Preliminary Consultation
MONTGOMERY COUNTY HISTORIC PRESERVATION COMMISSION
STAFF REPORT

Address:	7406 Maple Avenue, Takoma Park	Meeting Date:	6/12/2024
Resource:	Contributing Resource Takoma Park Historic District	Report Date:	6/5/2024
Applicant:	Ann Shalleck & James Klein (Paul Treseder, Architect)	Public Notice:	5/28/2024
Review:	HAWP	Staff:	Dan Bruechert
Proposal:	Partial demolition, fenestration alteration, construction of new rear addition, hardscape alterations.

Figure 2: Proposed right elevation showing the proposed screened-in porch.

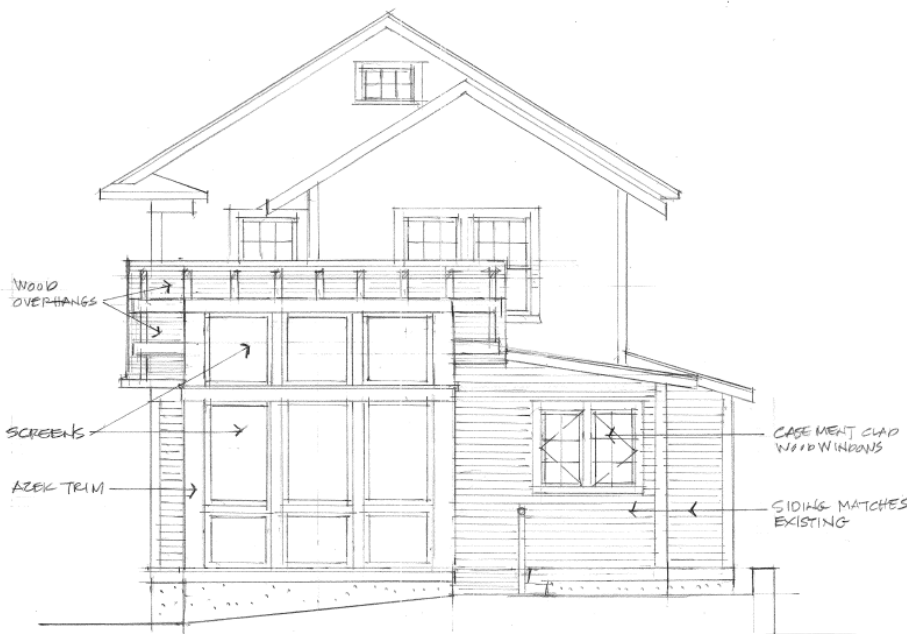
To the rear of the non-historic addition, the applicant proposes to construct a screened-in porch. The porch, which will be inset from the right-side wall plane by 1' 6" (one foot, six inches) and 10' (ten feet) on the left elevation, measures approximately 15' × 12' 6" (fifteen feet deep by twelve feet, six inches wide). The applicant suggests the porch will only be minimally visible from Maple Ave. The porch will be framed in wood, with Azek trim, and topped with a single 3:12 roof slope. This roof slope, and the massing it creates, are the primary reasons for this Preliminary Consultation.

Staff remains unconvinced that this approach is appropriate under the requisite guidance. The proposed roof form is more typical of mid-century architecture than an early 20th-century Colonial Revival house. Additionally, while the *Design Guidelines* state additions do not need to replicate early architectural styles, they are required to be compatible. Staff also notes that the proposed overhang on the right (north) side projects beyond the existing wall plane. Staff does not find the form or massing of the proposed addition to be compatible. Staff finds that the proposed porch could be further separated from the rear wall plane with a lower gable that then steps up to a taller rear gable roof. That roof could have an open gable end, which would allow more natural light and views of the backyard.

As a feature that is minimally visible from the public right of way, Staff recognizes the HPC should be more lenient in its application of the requisite guidance, but still finds the massing is out of character with the resource and surrounding district. While a variety of house styles have been employed in the District, staff cannot find an example of such a stylistic choice where a strong midcentury form was utilized as an addition to a Contributing resource.

- Whether the screened-in porch's roof form is appropriate? And if not;
- What modifications does the HPC recommend to make this an approvable project?

LEFT SIDE ELEVATION (WEST)

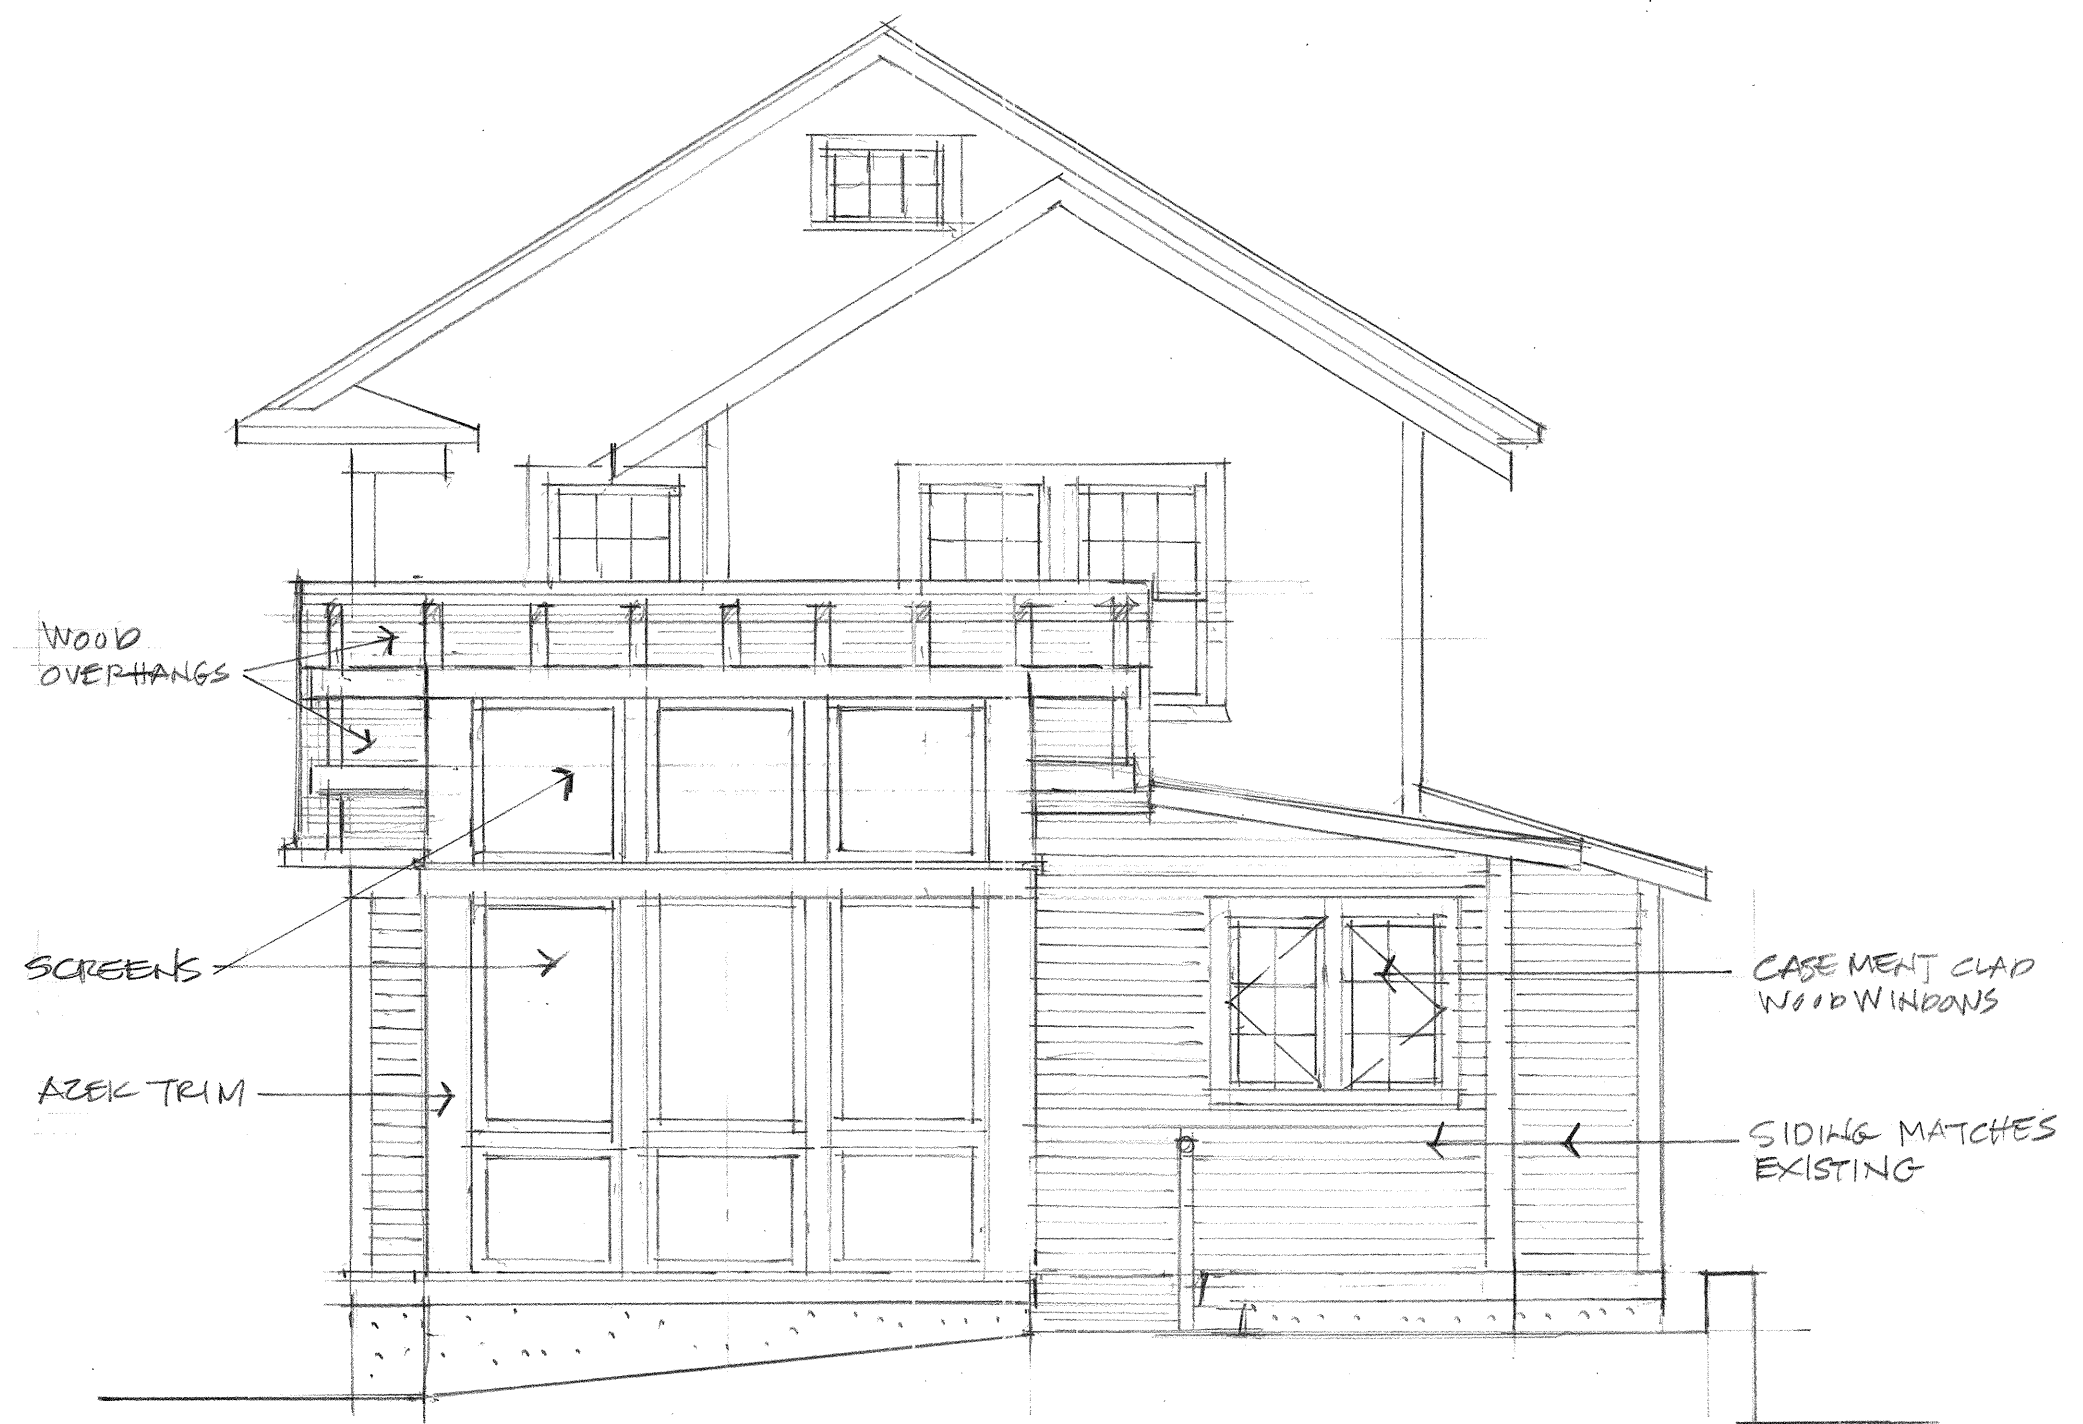
On the left elevation, the applicant proposes to remove one six-over-one wood sash window in the historic house and one six-over-one wood sash window in the non-historic addition. The window opening in the historic portion of the house will be enlarged and an aluminum-clad wood Chicago window will be installed in the opening. In the non-historic addition, the applicant proposes to install a three-window aluminum-clad wood casement assembly with a higher sill. The siding surrounding both window openings will be repaired to match the historic clapboards. Staff finds that while the applicant proposes to remove what appears to be a historic window, it is so far to the rear that its removal will not have a significant impact on the character of the house or surrounding district. Additionally, Staff finds replacing the window in the non-historic addition will not be visible from the right-of-way nor will it impact historic fabric. As with the windows on the right elevation, Staff cannot comment on the appropriateness of the window selected because specifications were not provided, but notes that a properly detailed aluminum-clad wood window with permanently affixed exterior and interior grilles and a spacer bar between the glass panes would be compatible in this location.

PROPOSED
 REAR ELEVATION (North)

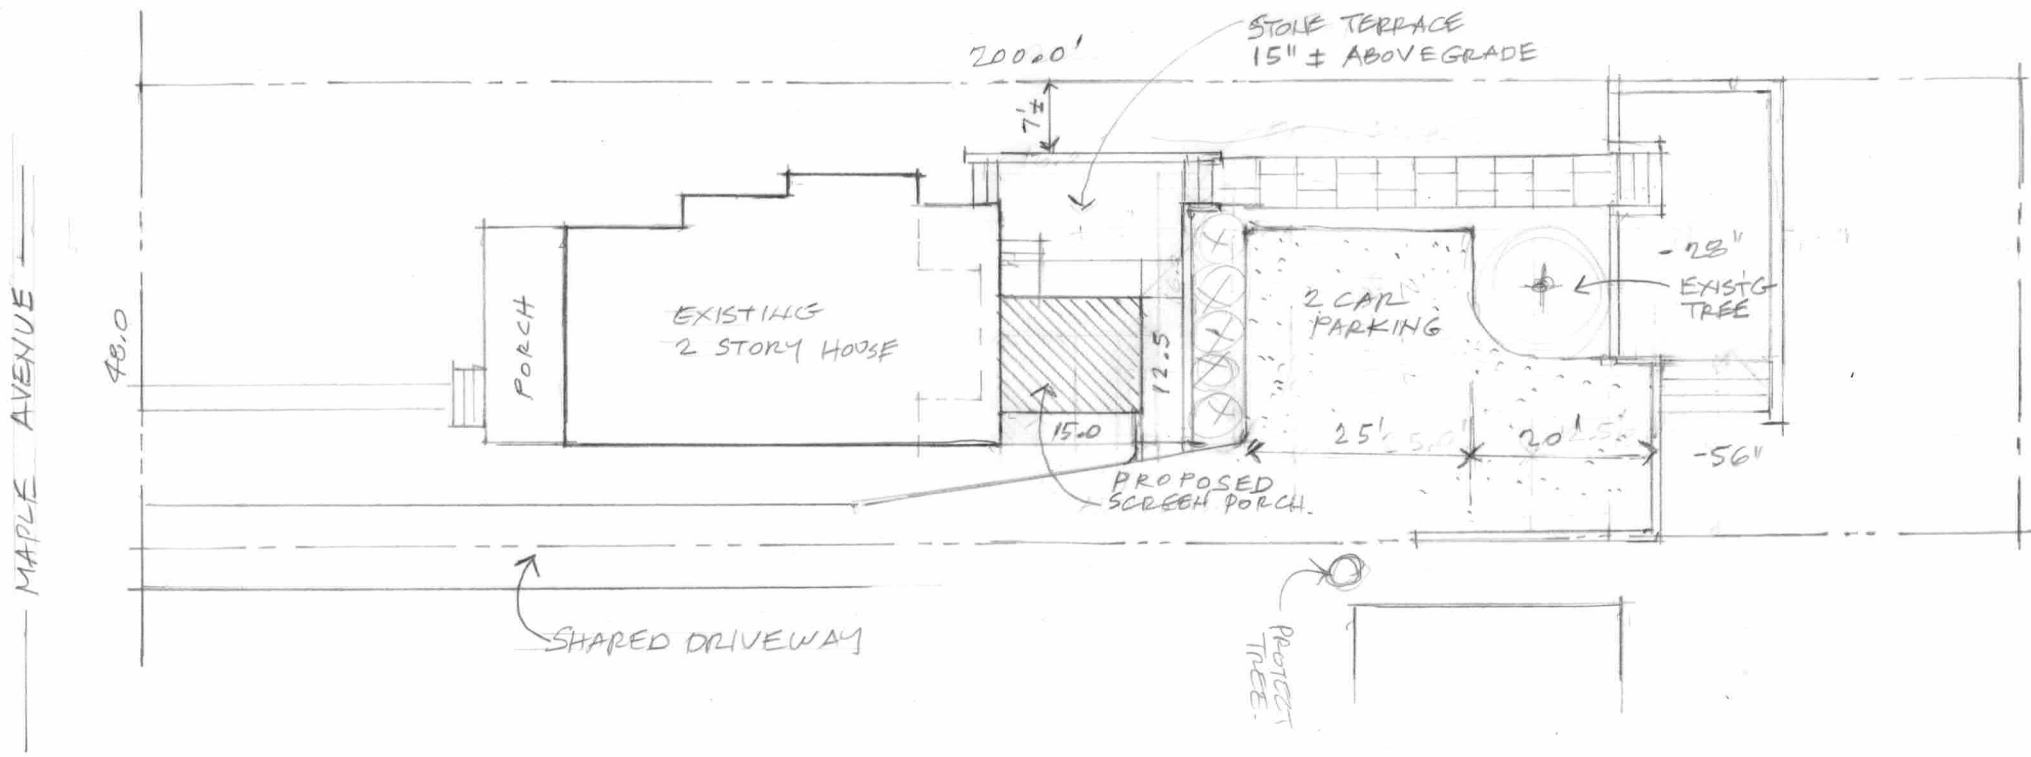
On the rear elevation, the applicant proposes to remove one window opening on the first floor and convert it to a door to access the screened-in porch (discussed below); and enlarge the other first-floor window opening to install a pair of six-light aluminum-clad casement windows. As with the other elevations, the applicant proposes to repair the siding to match the appearance of the historic clapboard siding. Because these changes are proposed for a non-historic portion of the house that is not at all visible from the public right-of-way, Staff finds the proposed changes will not have a significant impact on the character of the resource or surrounding district and would recommend the HPC approve the change with an appropriate window and door specification.
